V-13-19

Project/Property Address or Location: 6579 Taylor Rd.		Project Name/Business Name: Eastgate Commercial Park	
Parcel ID No.(s): 027-000008-00	Zoning Designation: OCT	Total Acreage: 7.6	
Description of Variance Requested: The current requirement is a 45 foot front parking setback. We are asking for a 22 foot front parking setback in order to meet the building space requirements due to the 80 foot right of way. Building code permits up to 0.5 foot candles in parking areas. We would ask for up to an average of 2.0 foot candles for safe and secure parking. Current requirements are for sidewalks to be added along the property frontage. Currently there are no sidewalks along Eastgate Blvd. We are asking to build the sidewalk once any other sidewalk is built.			
STAFF USE ONLY - Code Section(s): 1155.04(C)(1)(A) - Parking setback 1108.01(F) / 1107.01(d) - Sidewalks 1163.06(a) - Lightening			
APPLICANT Name-do <u>not</u> use a business name: Robert M. LeVeck		Applicant Address: 1500 W. Third Ave. Ste. 120 Co

PRELIMINARY SITE PLAN FOR:
EASTGATE COMMERCIAL PARK
THE CITY OF GAHANNA

Attn: Kelly Wicker, Administrative Assistant
RE: Project 6579 Taylor Rd Design Review Comment Letter S

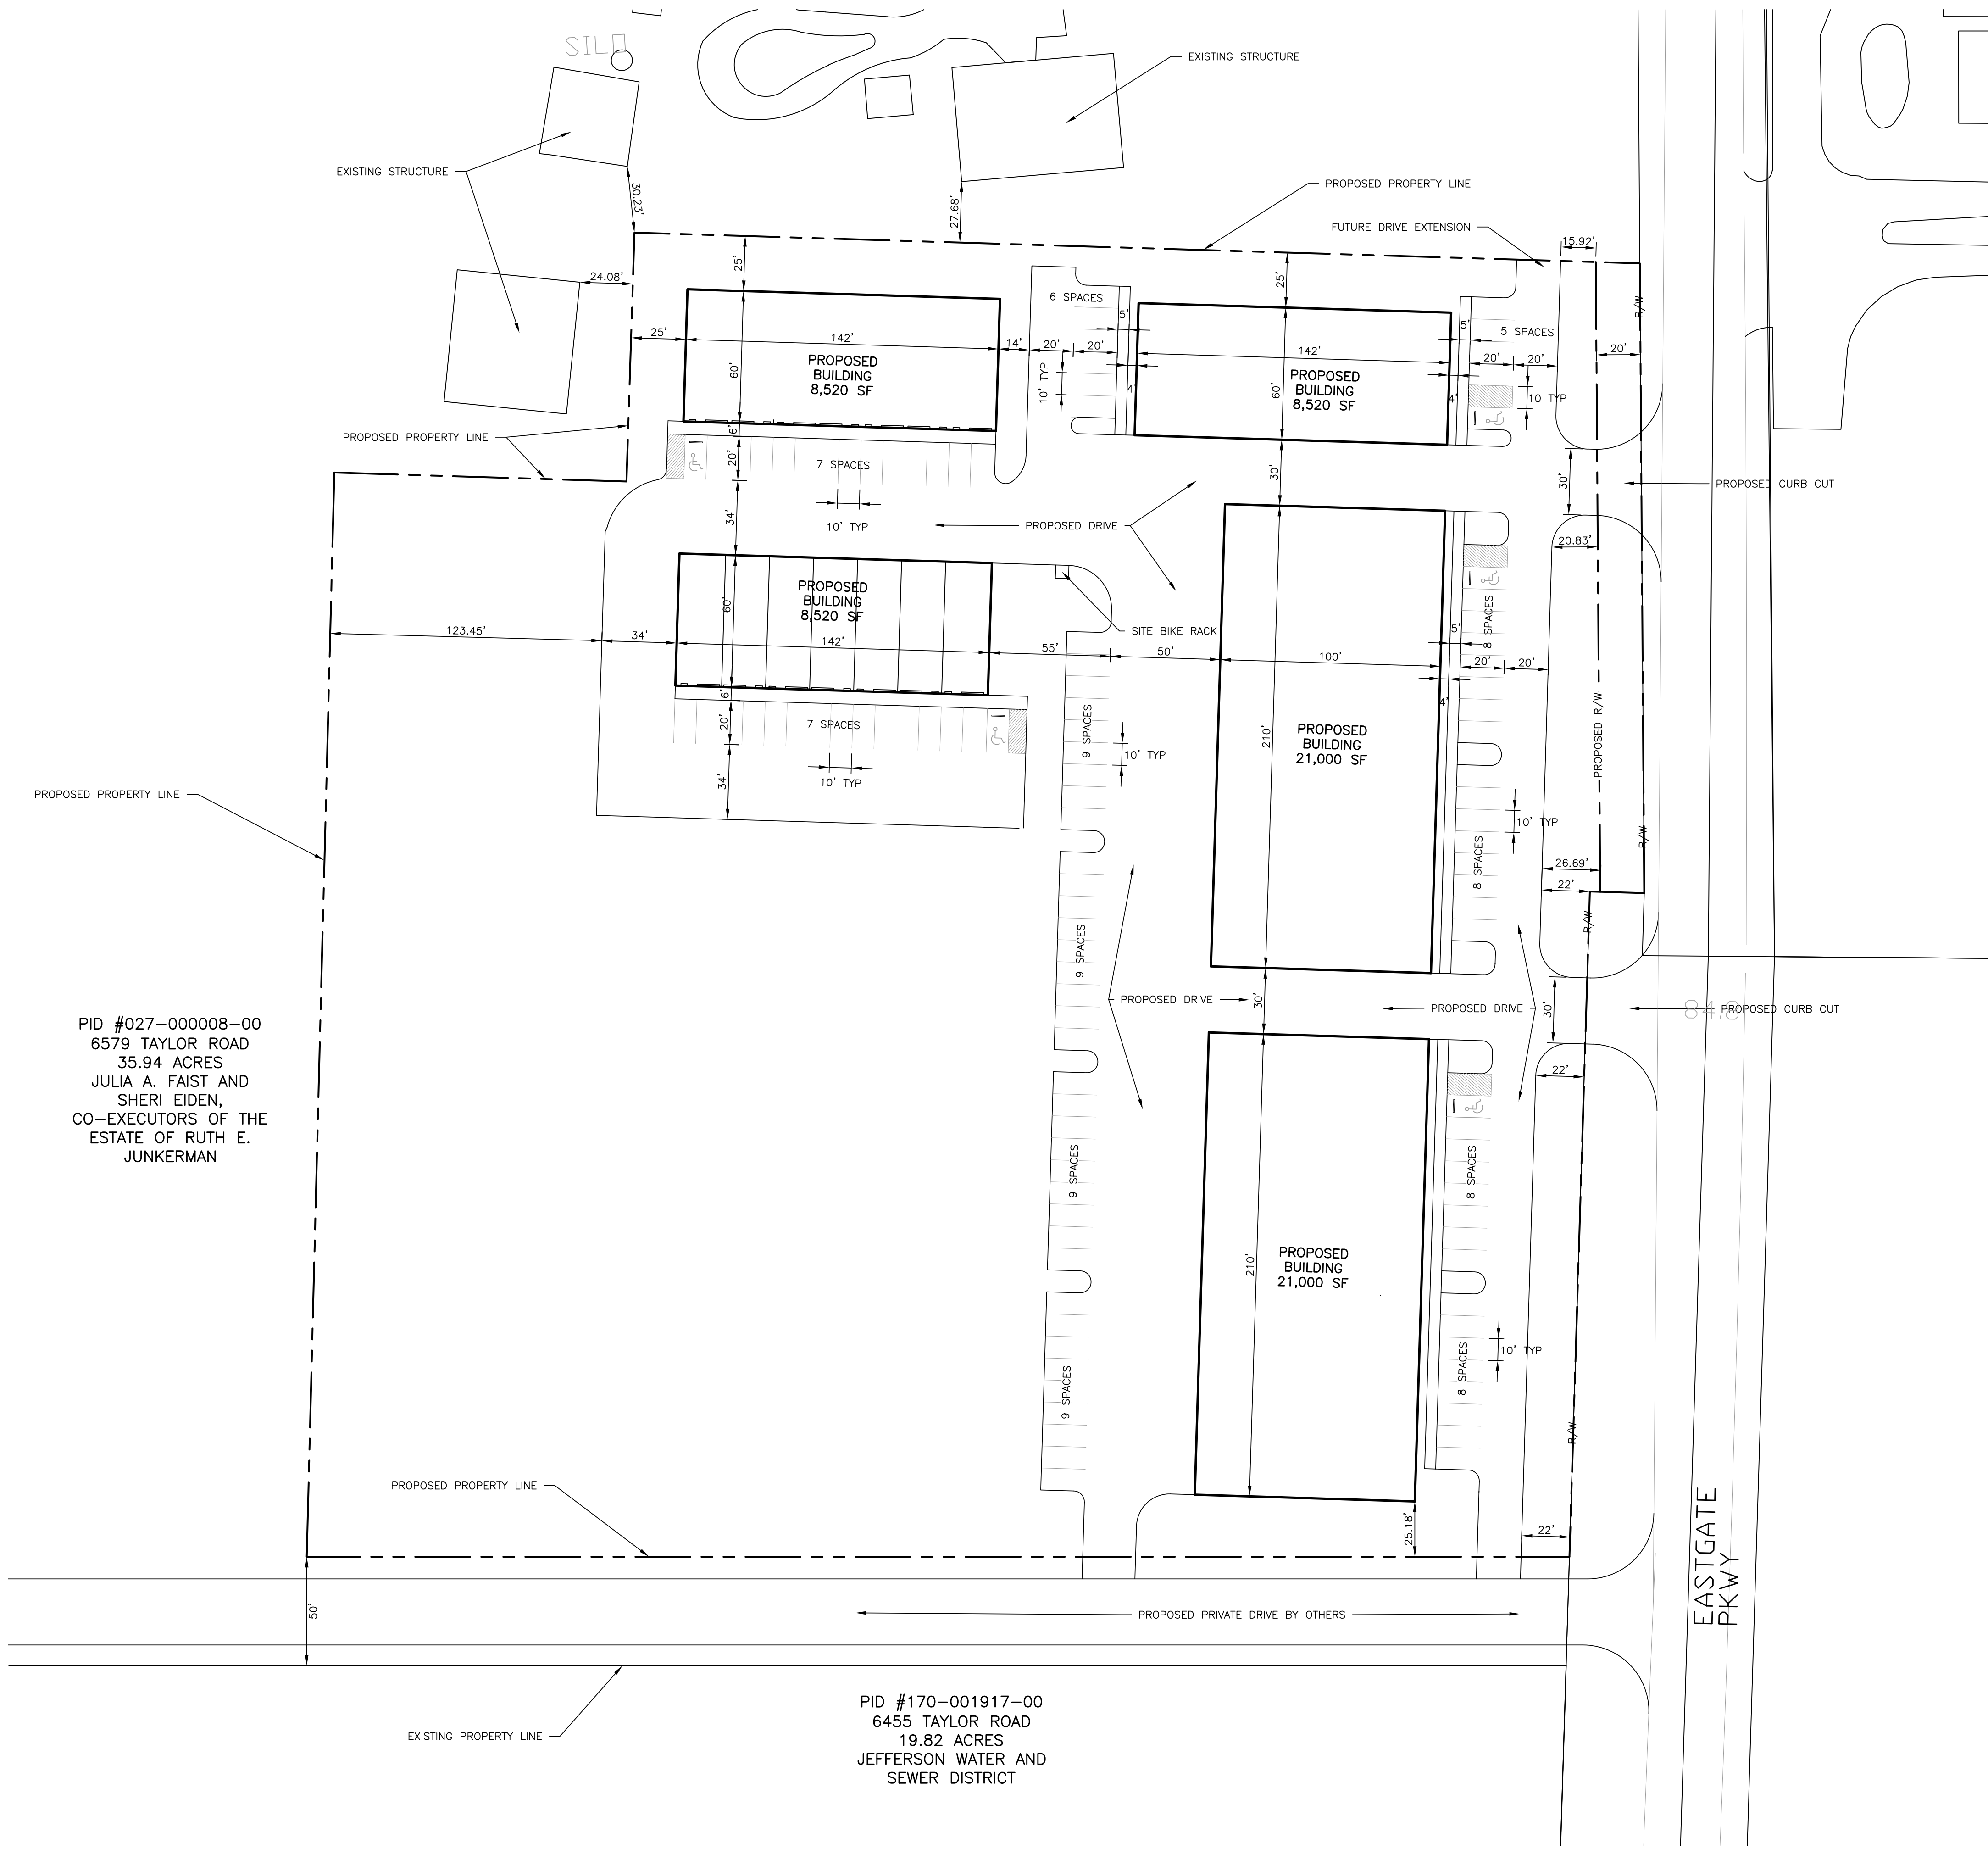
18. Chapter 1155.04(g) requires bike racks to be placed within 600' of the entrance to each building. Please revise the site plan to include bike racks. There's no minimum size requirements for the bike racks.

8/20/19 - It doesn't appear that the site plan was modified. Please revise accordingly.

19. The parking calculations on the site plan don't quite match the zoning code's requirements. In addition to parking spaces based on building size, additional parking is required based on the number of business vehicles. Please estimate this number and revise the chart.

Additionally, the square footage of buildings listed in the table don't match the site plan.

Please review and revise accordingly. FYI - the site has substantially more parking than what the code requires, only the parking table will require modification.

8/20/19 - The requested changes haven't been made. Please see Chapter 1163.02 for additional details.

20. Will there be any loading zones? If yes, then their location needs to be depicted on the site plan and the landscape plan will need to show the required screening (screened from adjacent properties and right-of-way with 6' tall screening).

8/20/19 - The revised elevations depict loading areas on all building types, therefore, the site plan and landscape will need modified to show these areas and the required screening. See Chapter 1155.06(g)(3)(A) for more details.

8. The landscape plan needs to calculate the parking area (spaces and drive aisles). The square footage of required landscape islands is 5% of the parking area. 1 tree per 100 square feet of required landscape island is required. The minimum tree caliper size is 3". Please revise the landscape plan for this calculation and increase the minimum tree caliper size.

8/20/19 - Based on the data provided, 46 trees need to be planted in the parking area, it appears that only 32 trees are planted. An additional 14 trees are required. Please revise accordingly.

9. The landscape plan shows barberry bushes at 24" in height planted along the parking area. No issues with barberry being planted as it is considered an evergreen, however, the minimum height is 36". Please revise accordingly.

8/20/19 - The landscape plan was revised to indicate that the parking lot screening will be accomplished by "Clethra Alnifolia". This bush is not an evergreen and therefore doesn't meet the requirements of the code. Additionally, the labeling on the landscape plan still indicates a planting size of 24". Please revise accordingly.

RESPONSE: Bike racks were shown in the prior submission but have been further clarified to reflect the 600' requirement.

RESPONSE: The Landscape Plan has the correct parking layout and building areas. Civil engineering will be updated to reflect the Landscape Plan.

RESPONSE: The adjoining property is owned by the same owner as this parcel. Further the loading areas are not visible from the public way.

RESPONSE: We show the calculation for the 5% parking area as required landscape islands. Further we have added additional trees to the landscape islands, 4 per island of 355+/-SF and 2 per island of 167 +/-SF. These are shown as 3" caliper trees.

RESPONSE: We have revised this to Chinese Juniper
